Date: January 13, 2014
To: David Nelson, via e-mail
Carter
171 17th St. N. W., Ste 1200
Atlanta, GA 30363
Subject: DRH14-00007
1570 S. Lusk St.
Lusk Place Apartments

Project/File: **Lusk Place Apartments/PUD13-00014/CFH13-00038**
This is a Planned Unit Development and Hillside Development application to construct a 4-story, 173,076-square foot, multi-family structure to accommodate 111 apartments and parking structure on 2.90 acres. The site is located at 1570 S Lusk Place in Boise, Idaho.

SITE PLAN

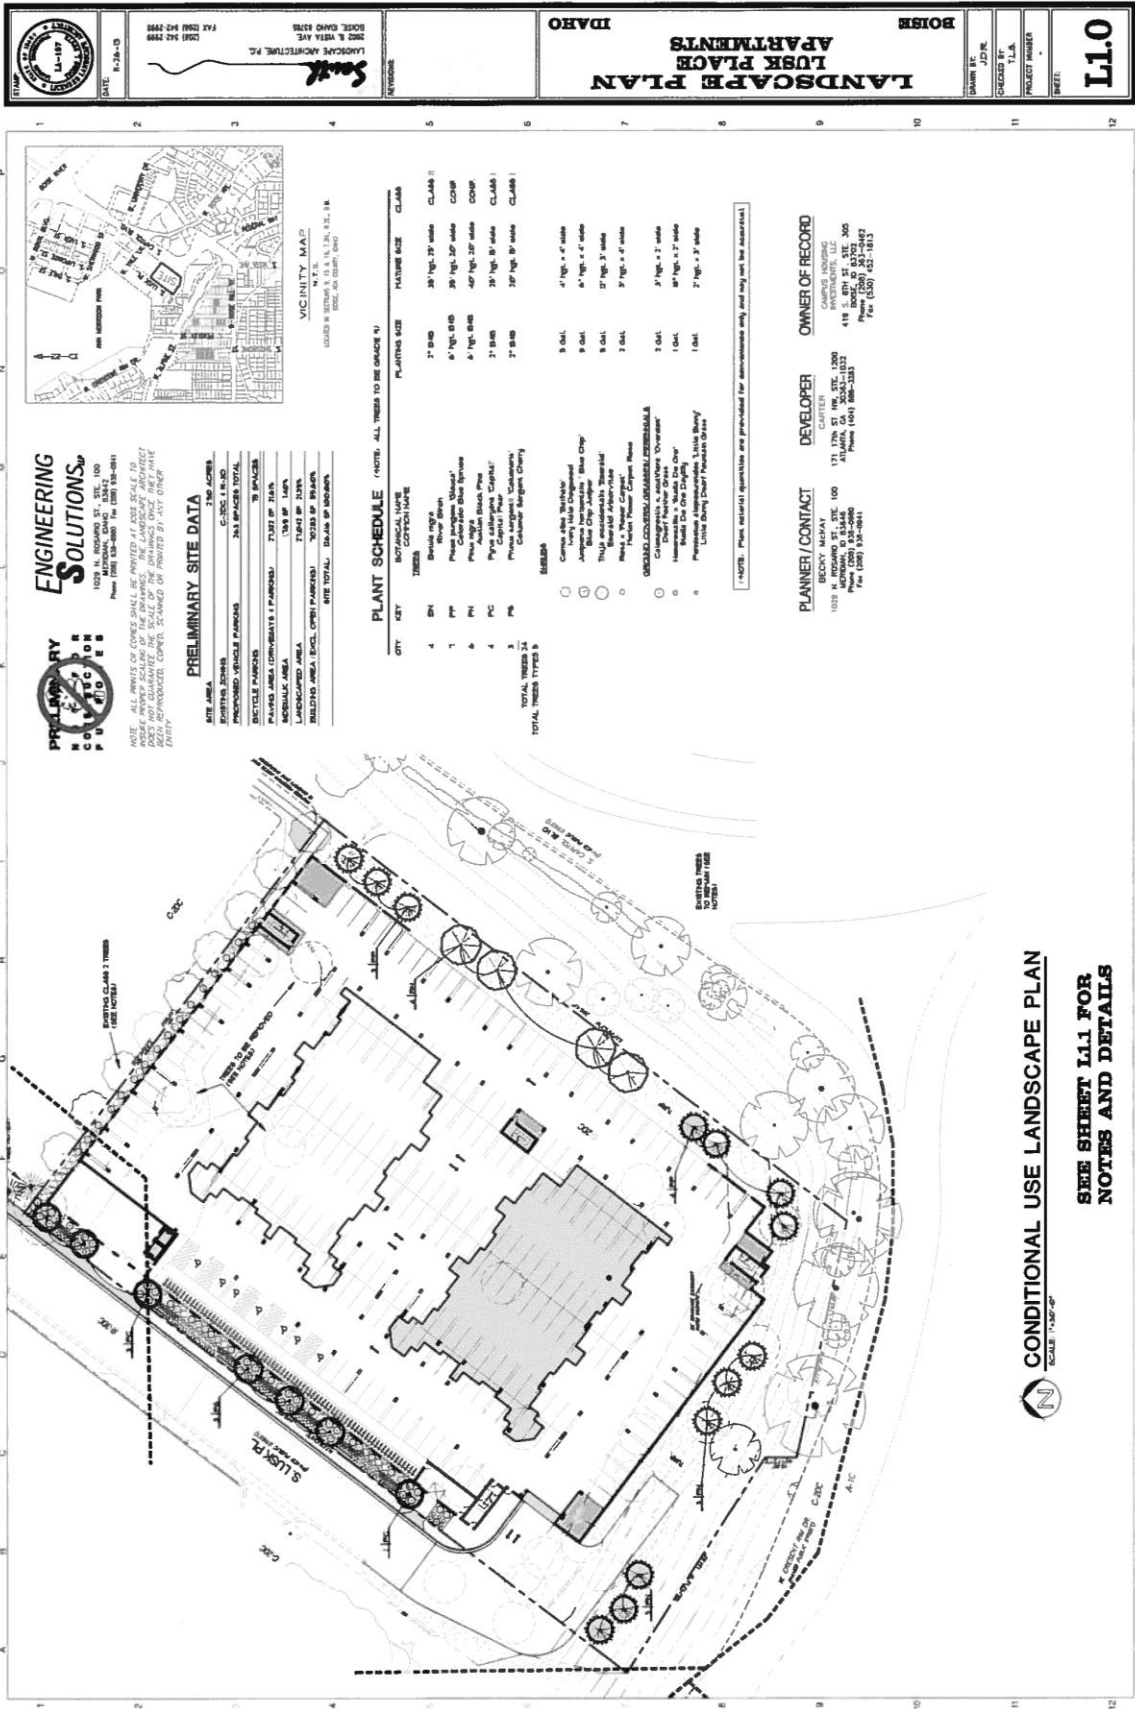
- c. **Applicant's Proposal:** The applicant is not proposing any improvements to Lusk Street abutting the site. The applicant is proposing an alternative turnaround in lieu of a cul-de-sac at the terminus of Lusk Place and a fire lane abutting the site.
- d. **Staff Comments/Recommendations:** Lusk Street is fully improved as a 36-foot street section within 50-feet of right-of-way; and meets the intent of the City of Boise's Lusk Street Master Plan as indicated above.

The alternative turnaround should be designed to provide 26 foot inside curb radius and 15 foot outside curb radius to allow for ACHD street sweepers to clean the street up to the curb line; and with a pavement width sufficient to allow the turning around of a standard AASHTO SU design vehicle without backing.

The applicant should be required to provide a permanent right-of-way easement for the alternative turnaround. The applicant should be required to provide written Fire Department approval for the fire lane prior to plans acceptance.

The applicant should be required to replace any deteriorated or deficient sidewalk, curb, gutter or pedestrian facilities along Lusk Place abutting the site, consistent with District Minor Improvements Policy 7203.3.

- c. **Applicant's Proposal:** The applicant is proposing to construct a 25-foot wide driveway located approximately 732-feet south of Yale Lane onto Lusk Place.
- d. **Staff Comments/Recommendations:** The applicant's proposal meets District policy and should be approved, as proposed.

1. Construct the alternative turnaround at the terminus of Lusk Place to provide a 26 foot inside curb radius and 15 foot outside curb radius to allow for ACHD street sweepers to clean the street up to the curb line; and pave the turnaround a width sufficient to allow the turning around of a standard AASHTO SU design vehicle without backing.

2. Provide a permanent right-of-way easement for the alternative turnaround.
3. Provide written Fire Department approval for the fire lane prior to plans acceptance.

4. Construct a 25-foot wide driveway located approximately 732-feet south of Yale Lane onto Lusk Place.
5. Repair or replace any deteriorated or deficient sidewalk, curb, gutter or pedestrian facilities along Lusk Place abutting the site, consistent with District Minor Improvements Policy 7203.3.
